UNITED STATES PATENT AND TRADEMARK OFFICE

APPLICATION NO.	FILING DATE	FIRST NAMED INVENTOR	ATTORNEY DOCKET NO.	CONFIRMATION NO.
09/719,323	01/04/2001	Toshikazu Ura	F-6768	7228

Office Action Summary

DETAILED ACTION

Sept. 25, 1973 JEAN-PIERRE CAILLEY 3,761,314
HIGH DISCHARGE RATE ELECTRIC CELLS AND BATTERIES
Filed June 22, 1971 3 Sheets-Sheet 1

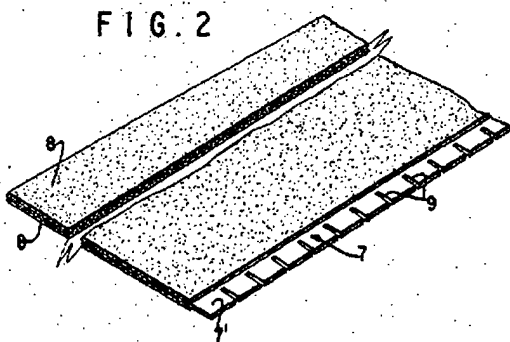
In claims 9 and 14, the limitation “a top edge of the at least one first current collector forms a continuous spiral edge bent orthogonally with respect to the axis of the spiral” is not in the original disclosure. The original disclosure does not show a continuous spiral edge bent orthogonally with respect to the axis of the spiral because there is no top view or bottom view of the electrode plate group in the Figures or any mention in the specification that a top edge of either the first current collector or the second current collector forms a continuous spiral edge

bent orthogonally with respect to the axis of the spiral. The method depicted in Figure 2 does not ensure a top edge of the first current collector that forms a continuous spiral edge bent orthogonally with respect to the axis of the spiral. As admitted by the applicant on page 15, lines 1-5 of the specification, folding may occur to some extent using the method depicted in Figure 2. Since there is no mention of slits being made at the edge of the current collector, the folding of the edge of the current collector into a plane will not result in a continuous spiral edge with a perfectly flat plane of 90°. Furthermore, folding of the edge onto itself may result in a discontinuous spiral edge. The edge of the current collector must be slit in order to form a continuous spiral edge with a flat plane of 90° as disclosed by Jean-Pierre Cailley in Figures 2 and 3 and reproduced below (US 3,761,314).
